UNITED STATES PATENT AND TRADEMARK OFFICE

Office Action Summary

09/808,299

DETAILED ACTION

FIG.:1

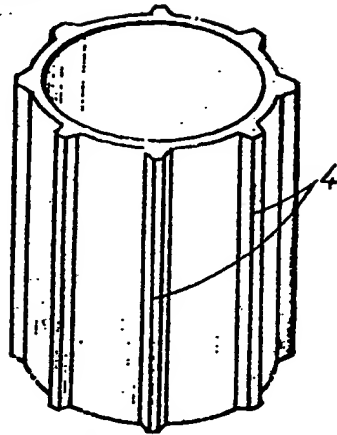
interpretation of the drawings shown in French document '148, it is unclear why only such an interpretation is valid. For example, the examiner looks at the same Figures (e.g. Figs. 1, 1a, 3) and sees a cylindrical segment with spaced notches therein. There is no claimed structural element precluding the interpretation that the space between the ribs can be considered as the discontinuities (meaning the notches).

FIG.:3

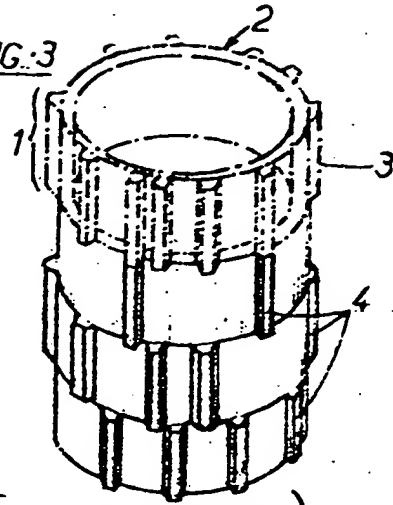
French document '148 discloses a VIV reduction mechanism comprising a plurality of columnar segments (see abstract, Fig. 3), each of the segments having a discontinuity provided by a notch formed by a radially inward-directed wall thickness discontinuity of the segment (see attached marked-up drawing Fig. 1a) and oriented substantially parallel to the axis of the structure, the segments being arranged with respect to each other so that the surface discontinuity of each segment is circumferentially displaced from the surface discontinuity of an adjacent segment, whereby the surface discontinuities of the plurality of segments define a discontinuous, stepwise, approximately helical pattern (see abstract). (Re claim 57), the discontinuities are spaced equidistantly around the exterior surface of the columnar segment (see Fig. 1a). (Re claim 58), the columnar segment has a radius that varies in length (see attached marked up Fig. 1a) between each two successive discontinuities.
